Drawing By: JimmyTan		Date: 8/23/2025	Title: Hamster Ball -Rotor			
Checked By:		Date:	Model NO. 22908			
Approved By:		Date:	Size	A3	Sheet 2 of 3	Revision V5.42

Hamster Revise Sheet

Drawing By: Jimmytan		Date: 8/23/2025		Title: Hamste Ball	
Checked By:		Date:		Model NO: 22908	
Approved By:		Date:		Size	A3
				Sheet	3 of 3
				Revision	V5.42

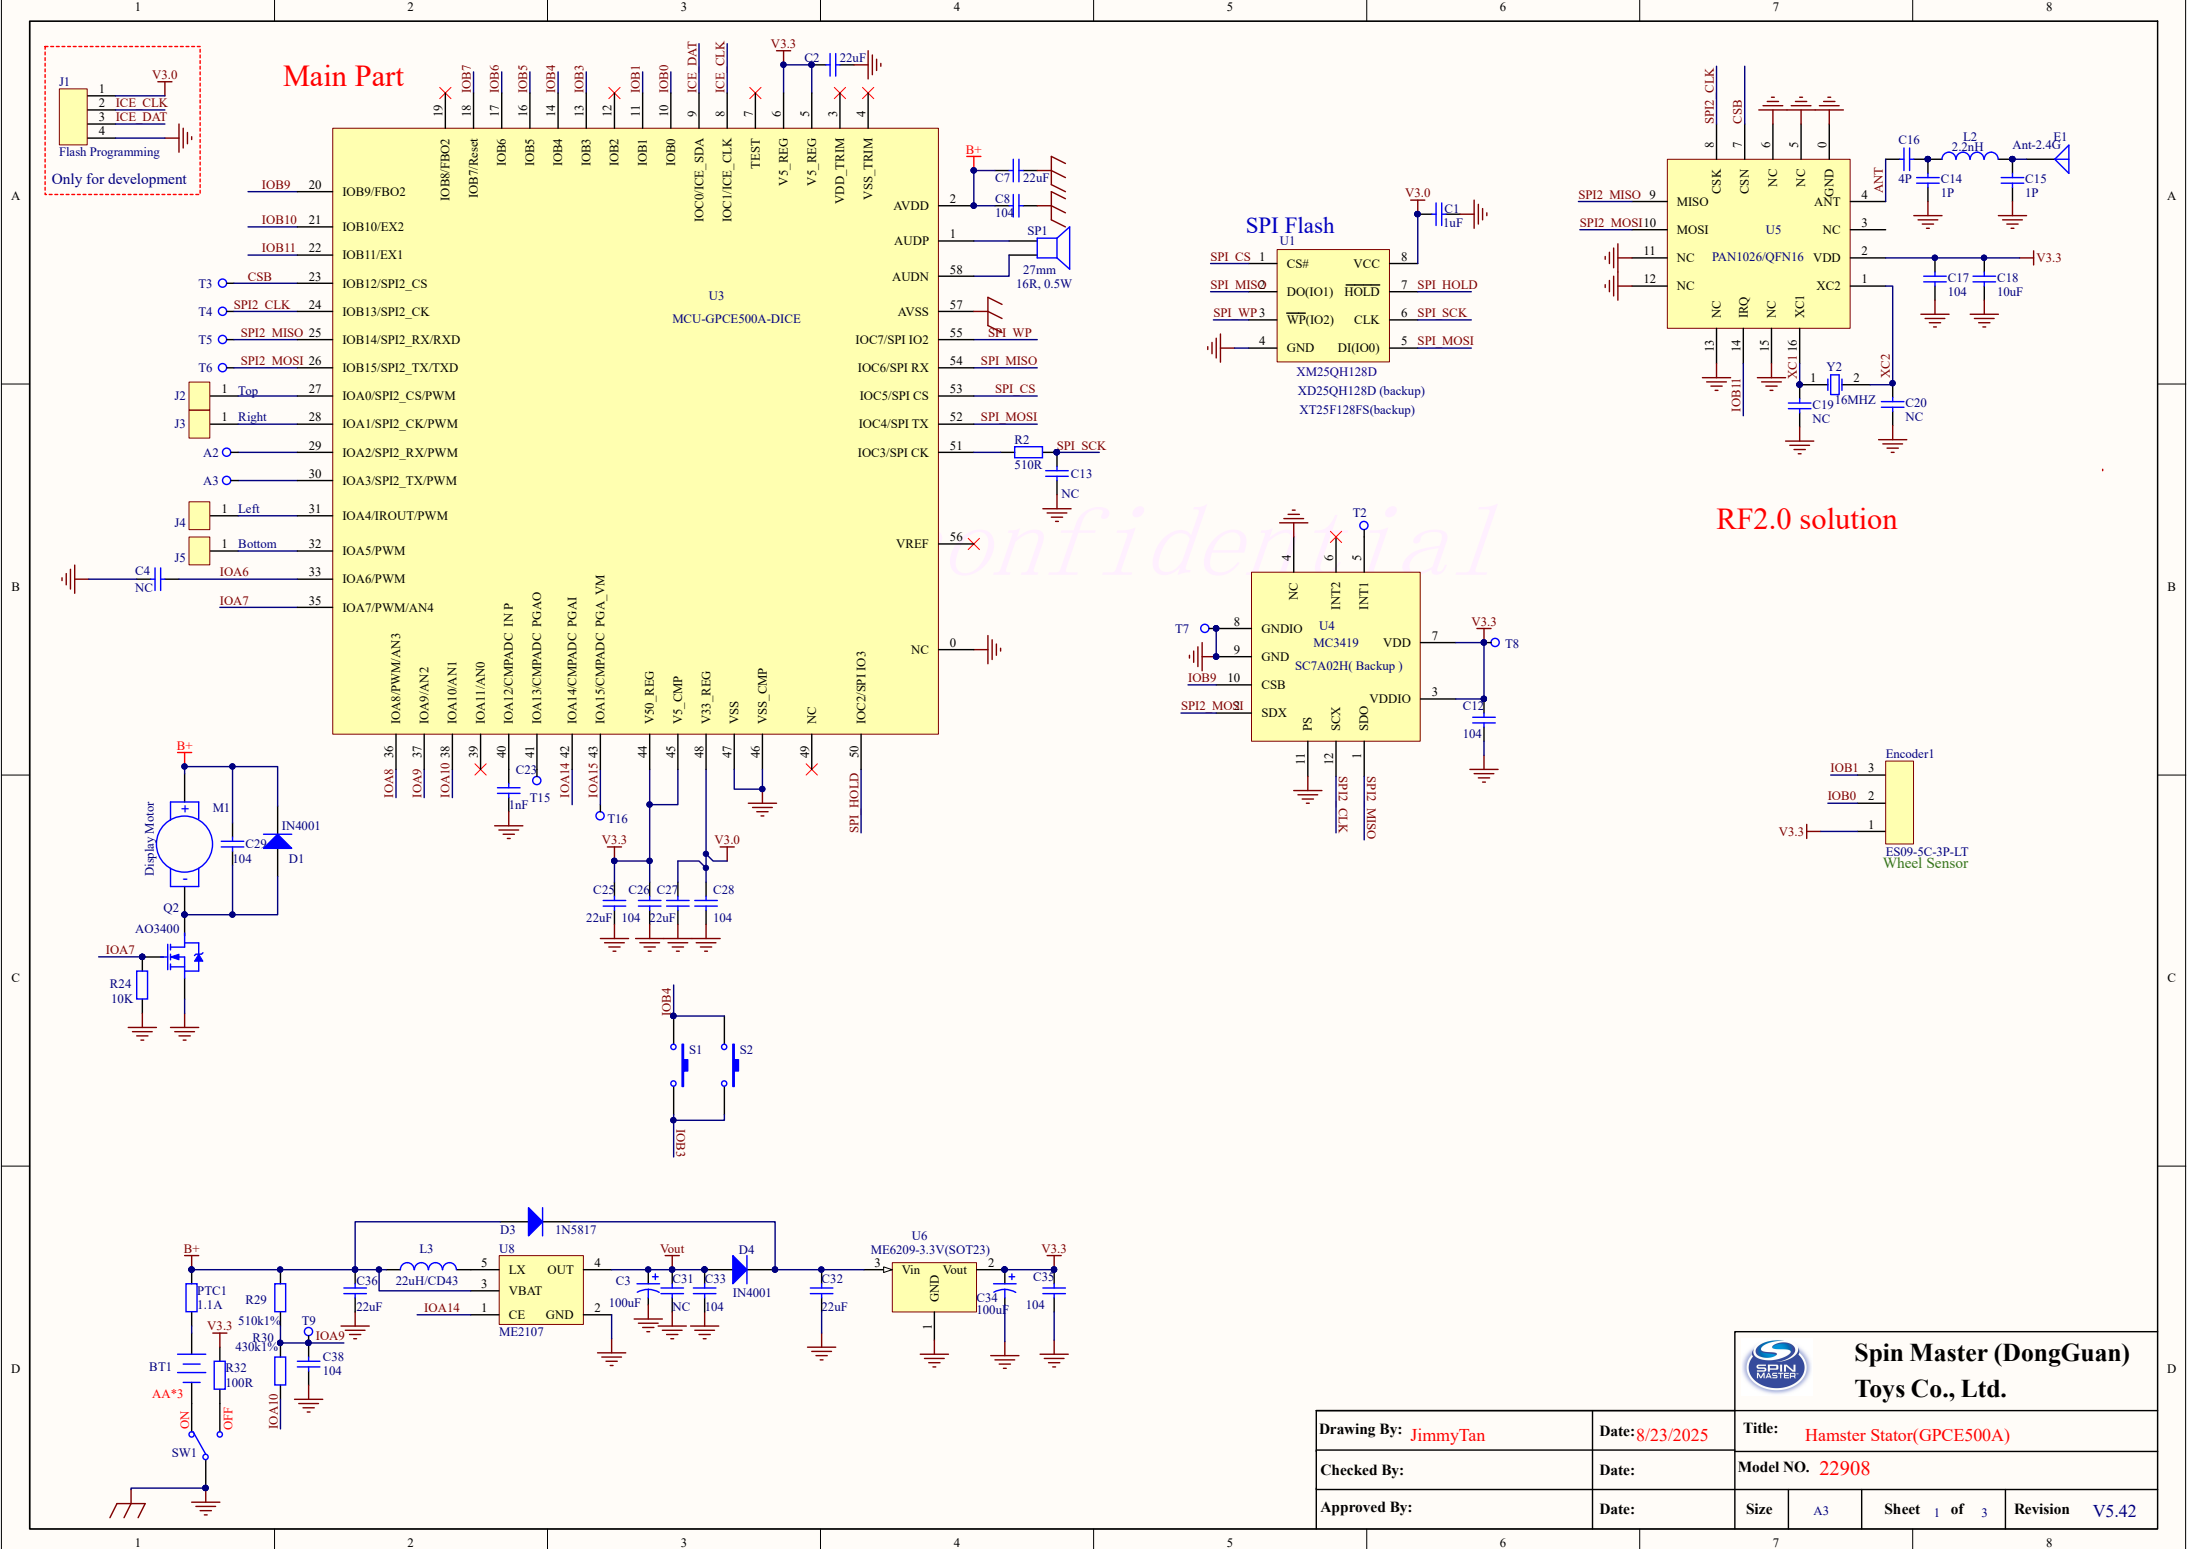
Version	Revise Date	Description
V5.00	2024-05-23	Original(RF2.0 solution)
V5.01	2024-06-21	Stator: 1. Revised the touch I/O(I/O A2&A3 are used for debugging and automated testing)
V5.02	2024-07-18	Rotor: 1. Removed one of the RF modules.
V5.03	2024-07-29	Rotor: 1. Added U2(Hall sensor) as an optional
V5.04	2024-08-07	Stator: 1.Front switch changed to 2 from 3 2. DC/DC changed to ME2107 from MT3608; 3.Added 2 SPI Models as backups
V5.05	2024-08-15	Stator: 1. Changed the pin2 of U2 connected to B+ from V5.0
V5.06	2024-08-20	Stator: 1. DC/DC changed back to MT3608; 2.Added Q3,R8,R9,R10 Rotor: 1. C24 changed to NC
V5.07	2024-08-30	Stator: 1. Removed C21, C22 2. R17 changed to NC Rotor: 1. C24 changed to 104
V5.08	2024-09-03	Stator: 1. R3,R4,R5,R6 changed to 0R
V5.09	2024-09-05	Stator: 1. R3,R4 changed back to 510K 2.Added C3
V5.10	2024-09-09	Stator: 1. R3,R4 changed back to 0R 2. DC/DC changed to ME2107 from MT3608;

V5.11	2024-09-10	Stator: 1. R3,R4 ,R11changed to NC and R12 changed to 0R;
V5.12	2024-09-12	Only for EP1 samples
V5.21	2024-09-13	For EP2 circuit diagram
V5.22	2024-09-19	Stator: 1.C3 and C34 changed to E.Cap(100uF)
V5.23	2024-09-20	Rotor: 1.Removed R2 and IR TX ;
V5.24	2024-09-25	Stator: SPI Flash is changed from 64M to 128M.
V5.28	2024-10-08	Stator/Rotor: IR changed to Hall sensor
V5.30	2024-10-17	For FEP circuit diagram
V5.35	2024-11-01	1.For FEP circuit diagram 2. To keep the same version with PCB layout
V5.42	2025-08-19	Stator: 1.R2 was changed from 100R to 510R and C13 changed to NC
